1st Further Information

**Proposed Temporary Warehouse (Excluding Dangerous Goods Godown) with Ancillary Facilities
and Associated Filling of Land for a Period of 3 Years in "Agriculture" Zone,
Various Lots in D.D. 107, Fung Kat Heung, Kam Tin North, Yuen Long, New Territories**

(S.16 Planning Application No. A/YL-KTN/1266)

Responses-to-Comments

Fig.6

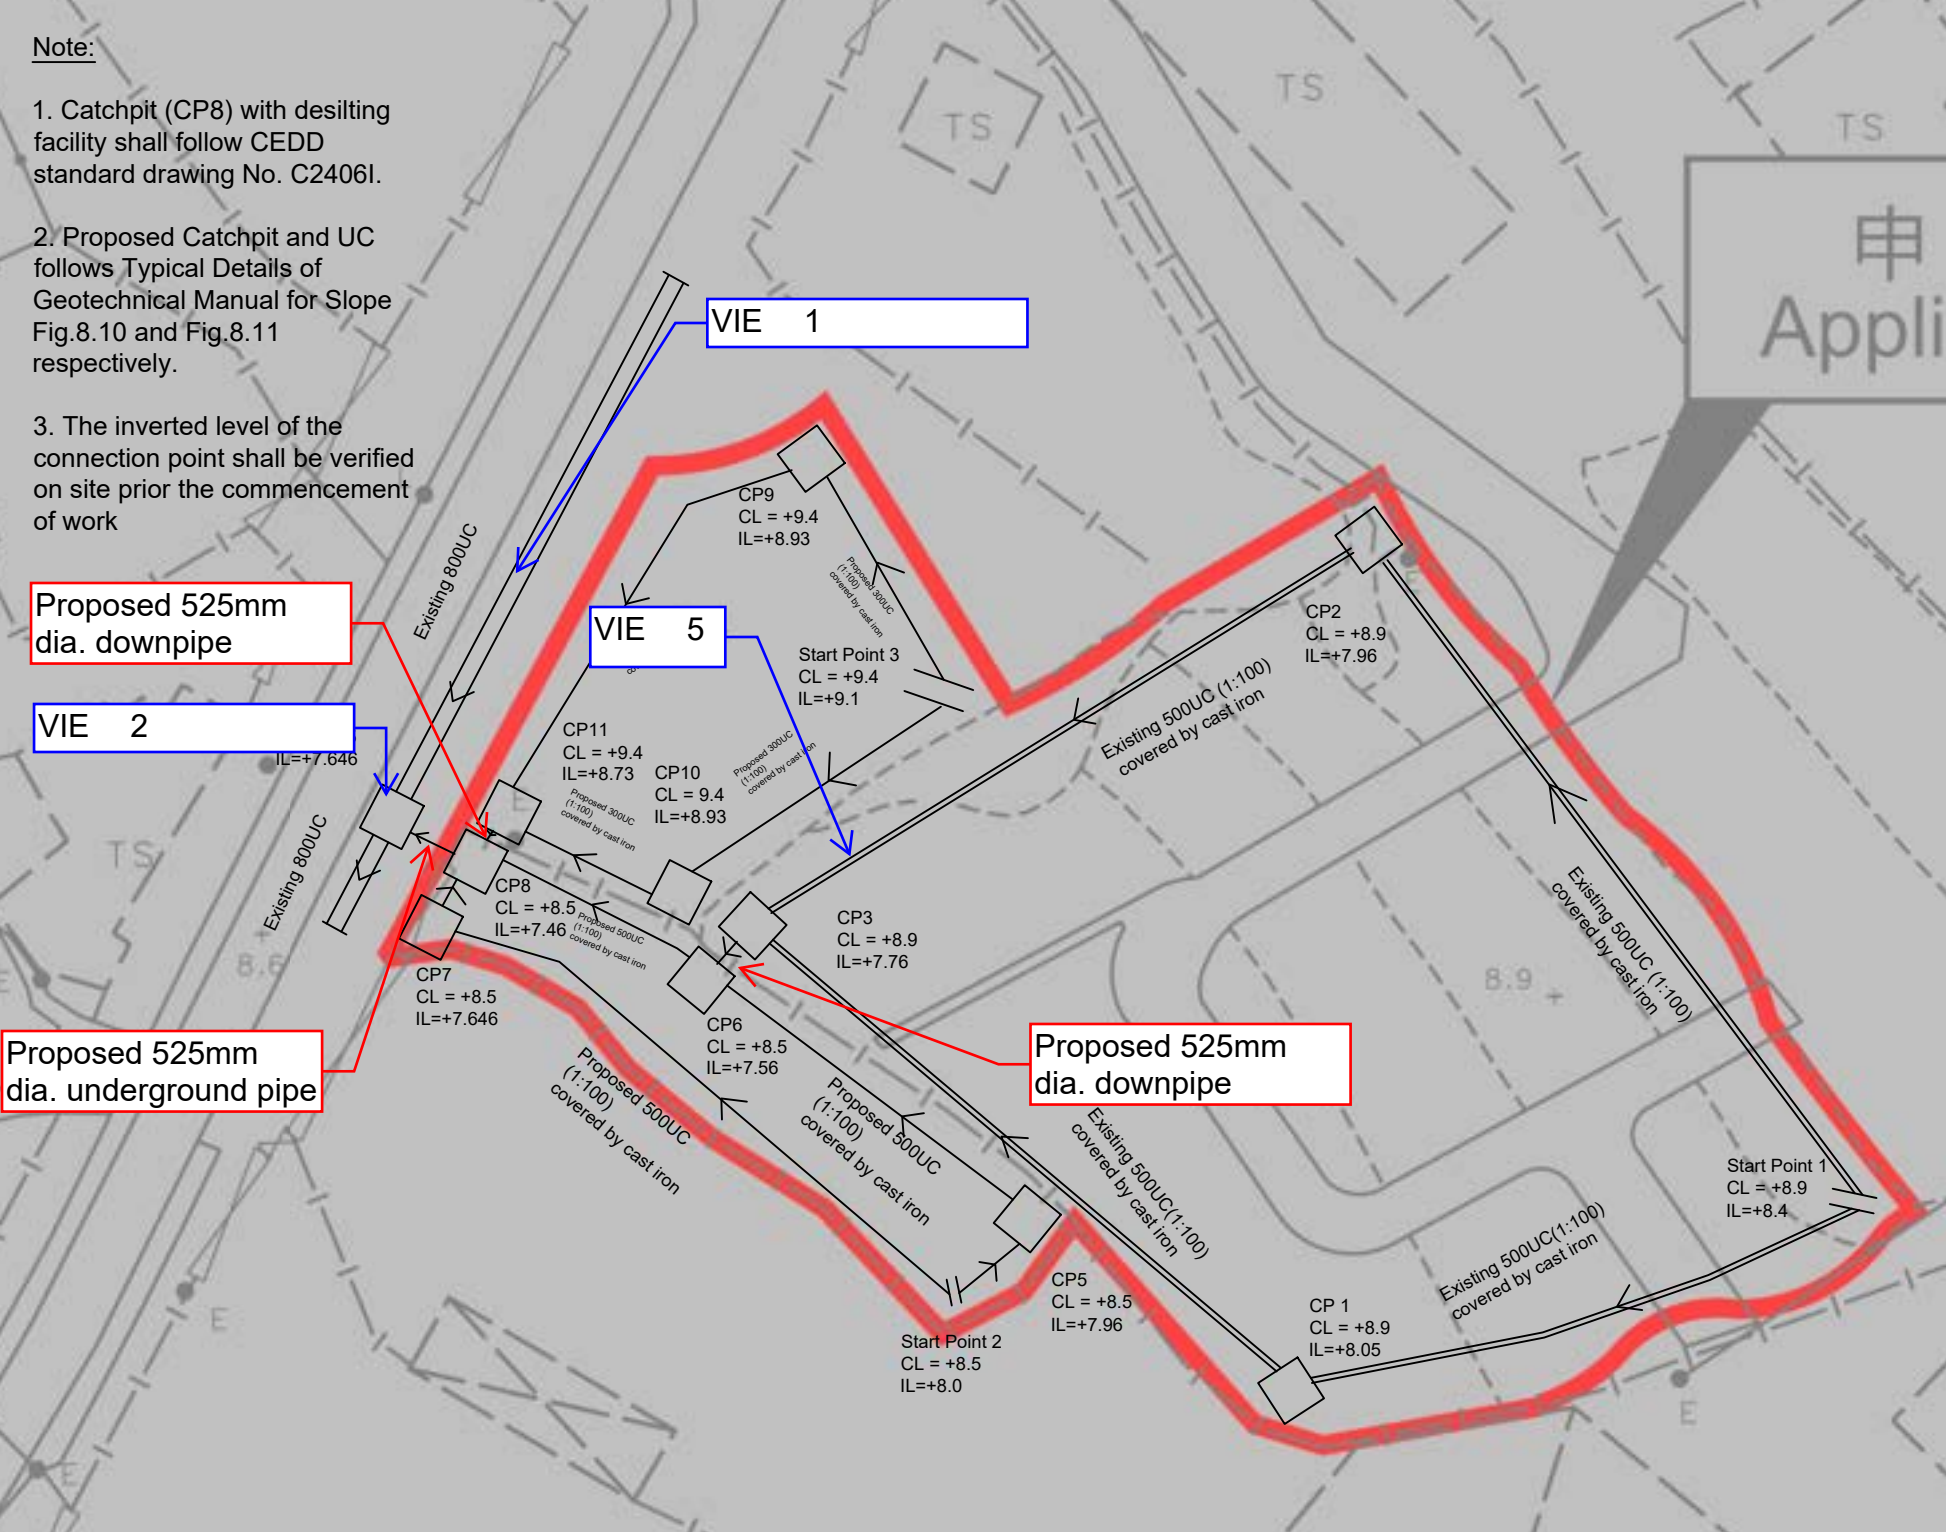
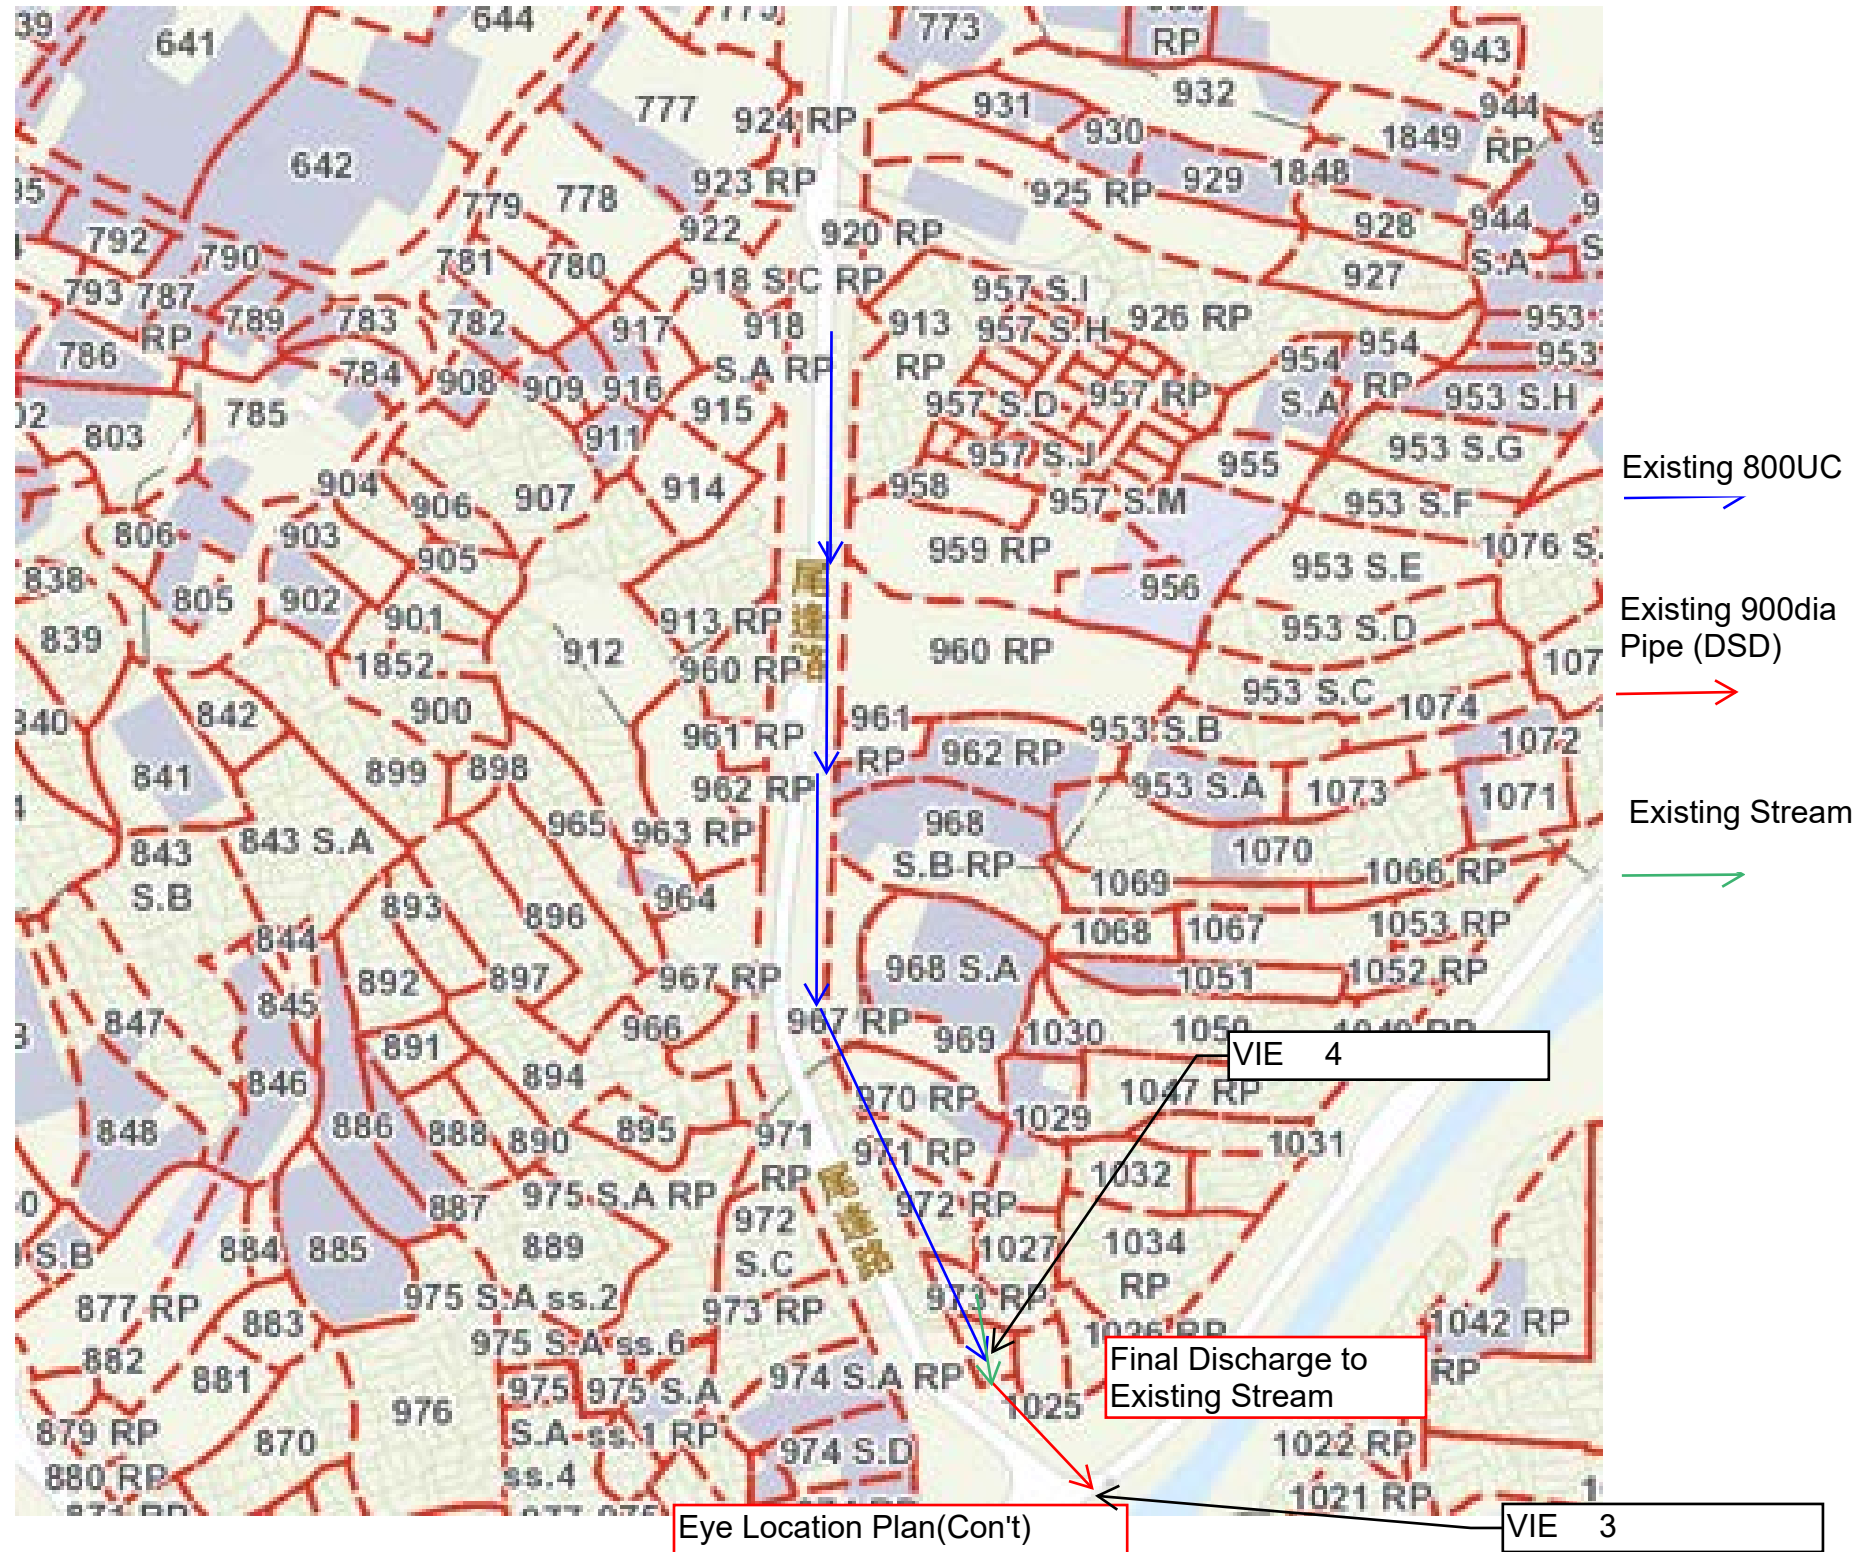
(3)	The applicant should provide site photos to demonstrate size of the existing surface channel mentioned in the proposal. Also, the applicant should provide site photos to show the connection of the existing 800 mm (W) surface channel and 900 mm dia. storm water pipe mentioned in the proposal.	Site photos have been demonstrate size of the existing surface channel mentioned in the proposal. Also, we have provide site photos to show the connection of the existing 800 mm (W) surface channel and 900 mm dia. stormwater pipe mentioned in the proposal (Appendix II).

VIE 1: Existing 800UC

VIE 2: Existing 800UC (Connection)

VIE 3: Existing 900mm dia. underground pipe

VIE 4: Connection Existing 900mm dia. underground pipe and Existing 800UC
